Sub: Diversion of 36.00 ha Reserved forest land for construction of Ganga Bawari Tank project in favour of Water Resources Division in Neemuch district of MP.

43rd Meeting of Regional Empowered Committee, Bhopal
Dt. 25/02/2020

Diversion of 36.00 ha Reserved forest land for construction of Ganga Bawari Tank project in favour of Water Resources Division in Neemuch district of MP (6-MPC011/2020-BHO).

DSS Analysis:

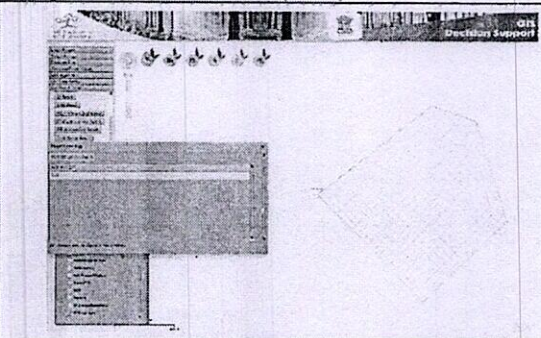
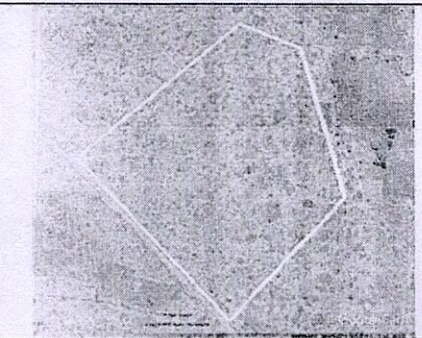
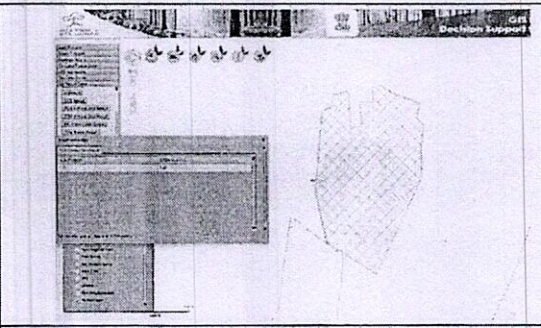
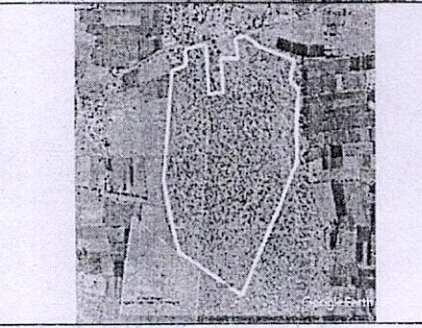
- 1) CA scheme not uploaded on webportal.
- 2) The DSS analysis and google earth show the construction work in the forest land which attract Para 1.21 of FCA Handbook 2019.
- 3) As per DSS analysis, the KML file of proposed diversion comes to be 41.43 ha in place of 36 ha and CA area (NFL) comes to be 62.45 ha in place of 36 ha.

Proposed land = 36 ha (shows violation in FL)	DSS area= 41.53 ha

DSS Image	Google earth Image
Proposed CA land = 36 (NFL)	DSS area= 62.45 ha

1. The DSS analysis and google earth show the construction work in the forest land which attract Para 1.21 of FCA Handbook 2019 for violation in Forest Land. Thus detailed report shall be submitted on following points

- a. The proposal for Penal NPV as per the Para 1.21 (ii) of FCA Handbook 2019.
 - b. The proposal for Penal CA from the State Govt. of MP.
 - c. The State Govt shall submit the details report as per Para 1.21 (ii) a,b,c & d of FCA Handbook 2019.

2. As per DSS analysis, the KML file of proposed diversion comes to be 41.43 ha in place of 36 ha and CA area (NFL) comes to be 62.45 ha in place of 36 ha. Thus, the area and KML file may kind be reconciled and correct map & KML file may be submitted and uploaded.
